**Model :** iR1210  
iR1270F

**Ref.No. :** FF-T01-L6 -000043-UK2

**Location :** READER DRIVE ASSEMBLY

**Subject :** Change of shapes of member parts

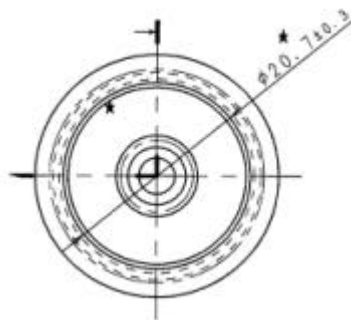
The gear pulley overlapping the idler gear has a depression on the flange due to molding. If the shaft leans, and consequently the idler gear is lifted, the idler gear might come into contact with the depression on the flange, resulting in noise. As a measure for it, round ribs are added to the top and under surfaces of the 45T gear (FU3-0076) and to the under surface of the 37T pulley/16T gear (FU3-0075).

Rib of FU3-0075-020

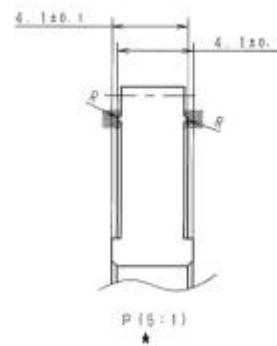
Ribs of FU3-0076-020

Be sure to replace the 45T gear (FU3-0075) and the 37T pulley/16T gear (FU3-0075) at the same time. Upon replacement of these member parts, if you find the countermeasure mylar, which was a temporary measure, be sure to remove it.
